PEACH BOTTOM ATOMIC POWER STATION, UNIT NO. 2

AMENDMENT TO FACILITY OPERATING LICENSE

Amendment No. 37
License No. DPR-44

ATTACHMENT TO LICENSE AMENDMENT NO. 37
TO THE TECHNICAL SPECIFICATIONS
FACILITY OPERATING LICENSE NO. DPR-44
DOCKET NO. 50-277

FIGURE 6.2-2

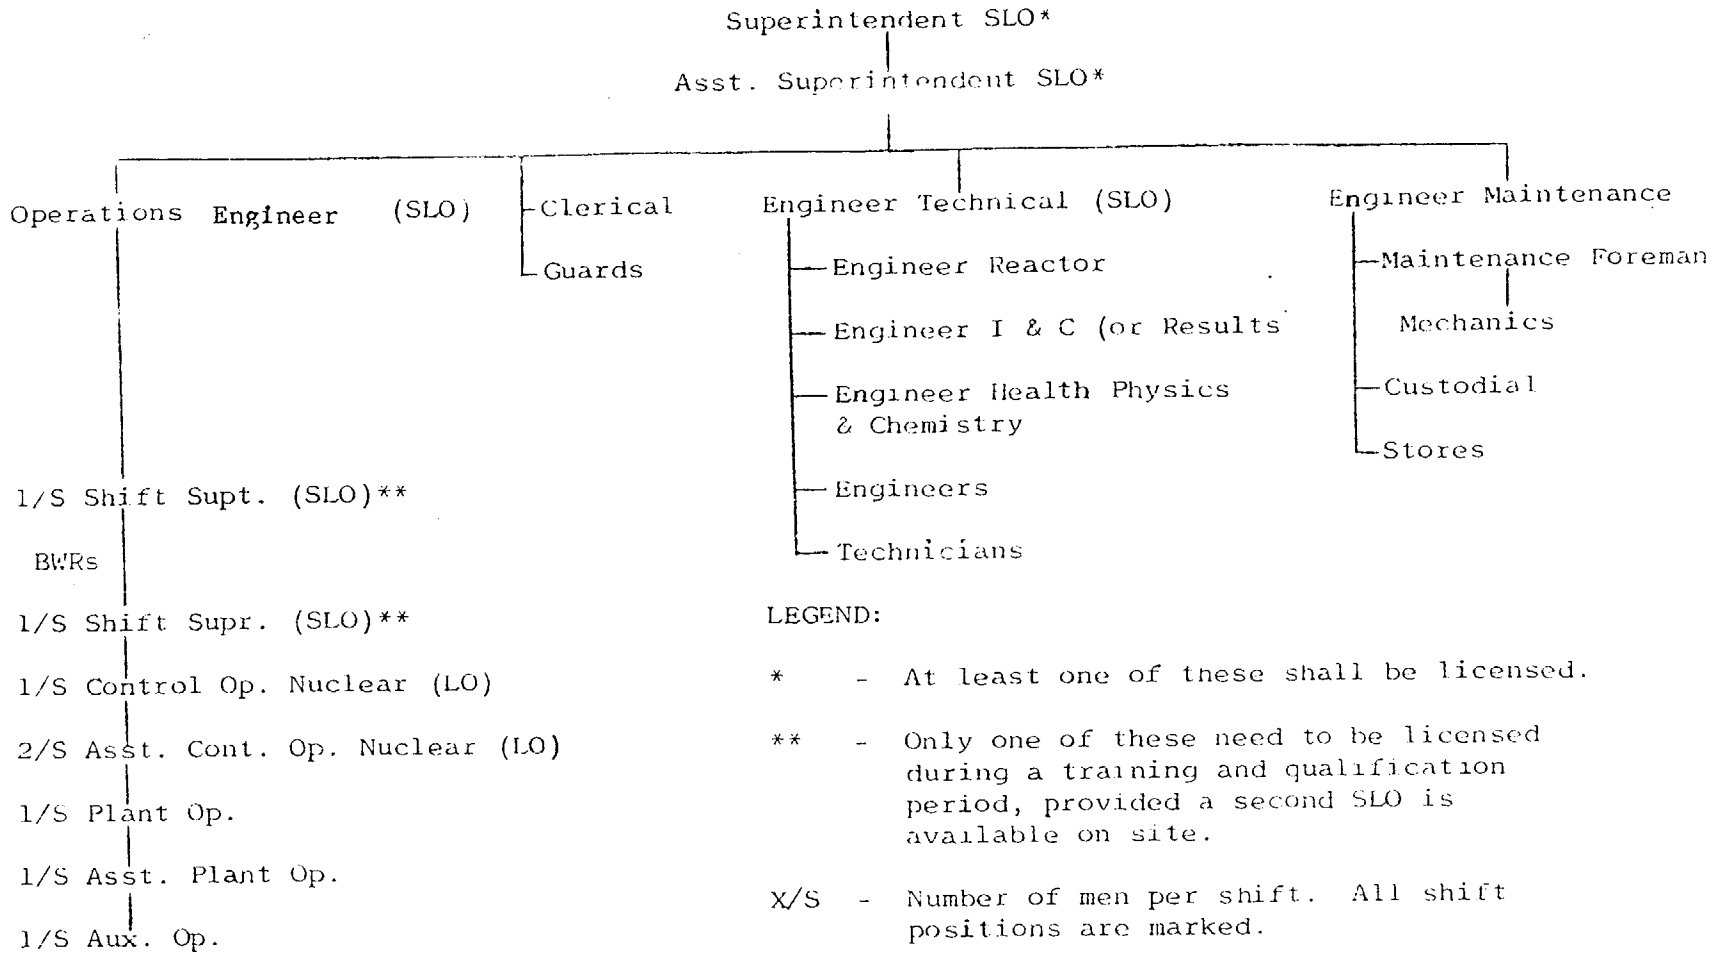
- 6.2.2 The facility organization shall be as shown on Figure 6.2-2 and:
- a. Each on duty shift shall be composed of at least the minimum shift crew composition shown in Figure 6.2-2.
 - b. At least one licensed operator shall be in the control room and assigned to each reactor that contains fuel.
 - c. At least two licensed operators, excluding the operator on the second unit, shall be present in the control room during reactor start-up, scheduled reactor shutdown and during recovery from reactor trips.
 - d. An individual qualified in radiation protection procedures shall be on site when fuel is in the reactor.
 - e. ALL CORE ALTERATIONS shall be directly supervised by either a licensed Senior Reactor Operator or Senior Reactor Operator Limited to Fuel Handling who has no other concurrent responsibilities during this operation.

The licensee proposed to revise the plant organization for conduct of plant operations and the membership of the PORC by adding an Operations Engineer, licensed as a Senior Reactor Operator. This position has the responsibility for planning and coordinating operations in accordance with the Technical Specifications. We have reviewed the licensee's proposal and determined that the total expertise of the staff will not be reduced but will be maintained at an acceptable level. Further we have determined that the function and qualification of the PORC have not been altered by the proposed revision and therefore it is acceptable.

FIGURE 6.2-2

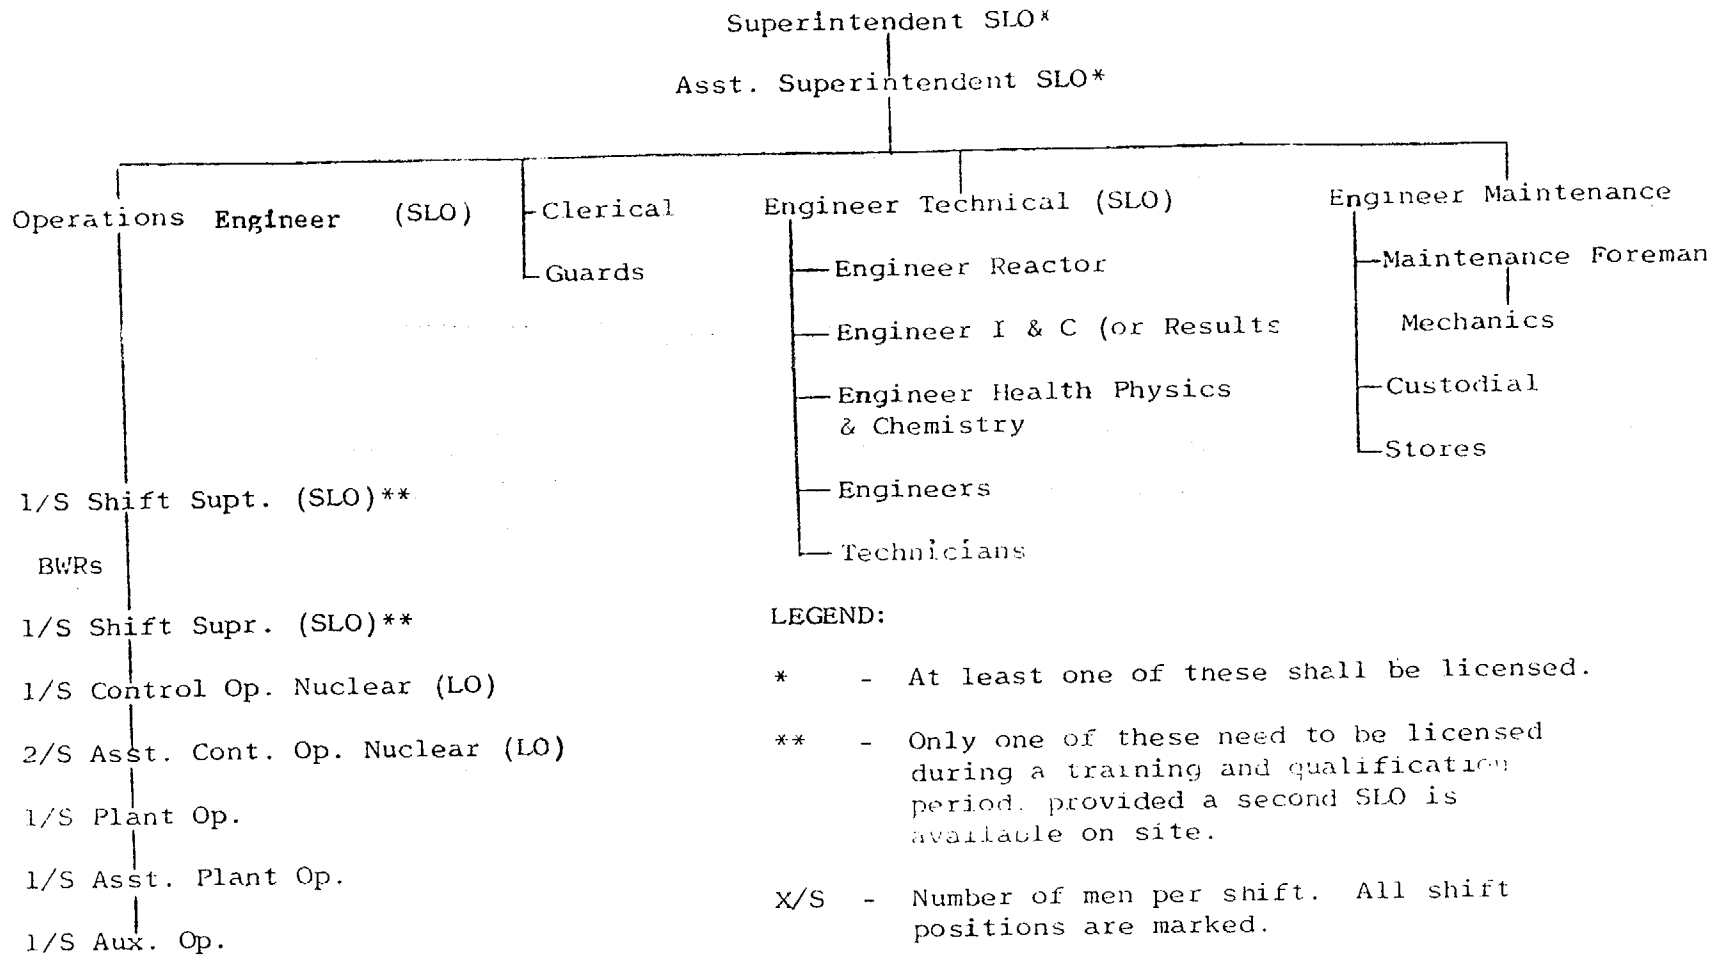
- 6.2.2 The facility organization shall be as shown on Figure 6.2-2 and:
- a. Each on duty shift shall be composed of at least the minimum shift crew composition shown in Figure 6.2-2.
 - b. At least one licensed operator shall be in the control room and assigned to each reactor that contains fuel.
 - c. At least two licensed operators, excluding the operator on the second unit, shall be present in the control room during reactor start-up, scheduled reactor shutdown and during recovery from reactor trips.
 - d. An individual qualified in radiation protection procedures shall be on site when fuel is in the reactor.
 - e. ALL CORE ALTERATIONS shall be directly supervised by either a licensed Senior Reactor Operator or Senior Reactor Operator Limited to Fuel Handling who has no other concurrent responsibilities during this operation.
